## Technical Advice – Water Engineering - by Mark Groves

**To:** Andrew Balme  
**From:** Jeremy Robertson  
**Office:** Taupō  
**Date:** 19 December 2025  
**File/Ref:** 2-38161.00  
**Subject:** Tekapo B Weir Assessment - Summary of Findings

**To:** Andrew Balme – Engineering Manager, Civil & Dam Safety  
**From:** Jeanette Tucker, Jan Stanway, Jeremy Robertson  
**Cc:** Lewis Thomas  
**Ref:** 2-38161.00 Tekapo B Submerged Weir  
**Date:** 26-03-2026  
**Subject:** *Tekapo B Power Station Submerged Weir – Damwatch Document Reviews*

Figure 1: Weir and rib (sill) concrete structure showing the cap and base sections

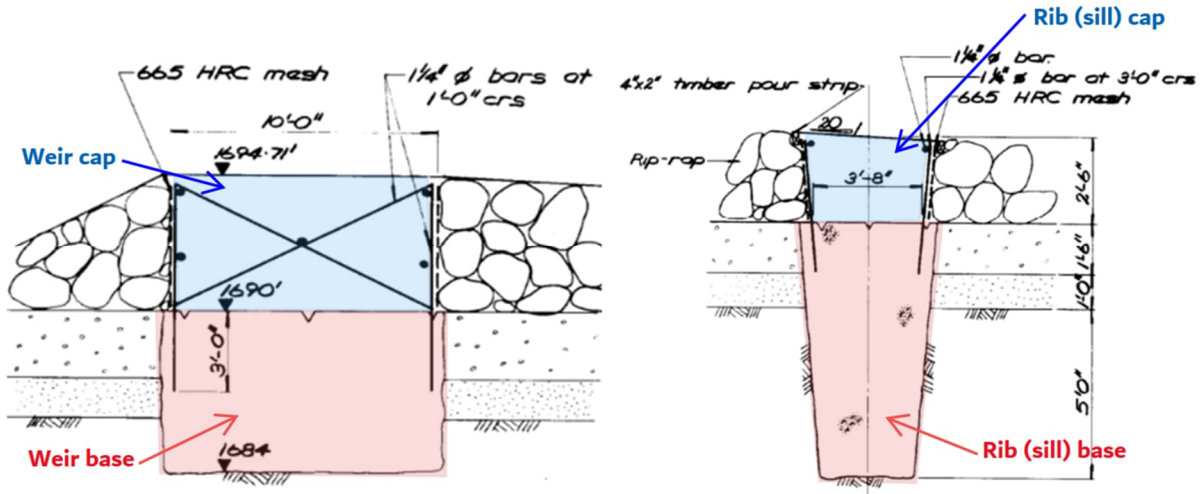
- A loss of ground (undermining) around any weir or sill that results in movement (lateral displacement or rotation) of the concrete that forms the weir and sills. Any movement that results in movement of riprap across the weir and/or sills compromises the performance of the weir and chute.

- Loss of structural connection of the weir or sill ‘cap’ (also referred to as ‘upper weir’ by Damwatch) from the lower concrete base. Refer to Figure 1 below for clarification the cap and base sections of the weir and sills.
- Existing damage to the concrete weir and sills has the potential to reduce the capacity of the concrete to sustain the lateral loads on the concrete to support the riprap and the hydraulic forces from water.
- Damage to the concrete weir and sills due to concrete condition when they are exposed due to draw down and reused as a weir and chute in the future.

Figure 2: Weir and rib (sill) concrete structure showing loads to be resisted by concrete caps

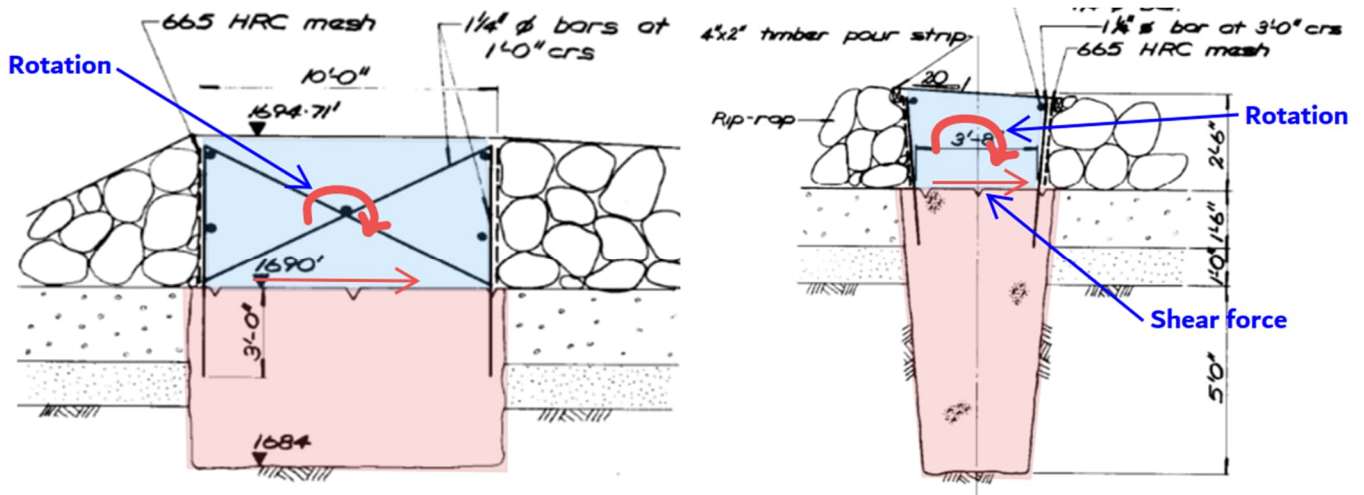
To bring the chute back into operation today the connection of the concrete cap to the weir is essential to enable the weir and sills to achieve their intended design purpose to hold back the riprap during design water flow. The connection of the concrete cap would need to resist the lateral loads due to the gravity load of the upstream riprap bearing on the cap as well as the lateral force on the cap as a result of the hydraulic flow of water down the chute. The lateral loads will create a shear force at the interface of the cap and the base concrete (i.e. at the construction joint) and an overturning force on the cap. Note given the dimensions of the weir cap the weight of the cap is expected to be sufficient to resist any overturning force on the cap. It is possible that the weight of the sill cap may be insufficient to resist the overturning and assuming there is sufficient section of reinforcement remaining in the vertical rebars these could provide the necessary overturning resistance if required. The forces to be resisted are shown in Figure 2 below:

The mechanism to resist the loads shown in Figure 2 will be by one or both of the following load paths:

1. Where the rebars were not surrounded by concrete the vertical reinforcing bars do not act as normal reinforced concrete dowels that provide shear connection between the different concrete lifts, instead they hold the concrete in place if they are in contact with the concrete. If there is a gap between the rebar and the concrete as shown in Figure 2-5 of WSP Structural Condition Assessment report (dated 19 December 2025), the concrete would need to slide and/or rotate to bear up against the downstream rebar to provide the shear and overturning resistance.

2. It is currently unknown if the construction joint was roughened between the concrete base and concrete cap. As noted by Damwatch (first paragraph page 6) if the standard Ministry of Works' specifications for concrete works were followed for these temporary works, then the construction joints are likely to have been cleaned and roughened before placement of the second lift. Given that this structure was temporary works intended for short duration life it is not certain that the standard concrete specification was followed and the construction joint was cleaned and roughened. If the joint was cleaned and roughened the joint would provide aggregate interlock and resist shear forces in addition to any vertical reinforcement in contact with the concrete. If the joint was not cleaned and roughened the construction joint would have little to no shear resistance and the vertical reinforcement will be required to keep the cap in place.

The current condition of the vertical 1.25 inch (approx. 32mm reinforcement) is unknown. Photographs show corrosion.

WSP recommendation: Given that the importance of keeping the concrete caps connected to the concrete base to achieve the structural performance of the concrete weir and sills, and given that the vertical reinforcement has an unknown extent of corrosion, and is known to have varying gaps between the reinforcement and the concrete it is recommended drilling and grouting new steel dowels along the length of the weir and sill beams, to ensure the connection between the concrete cap and base remains during use of the structure.
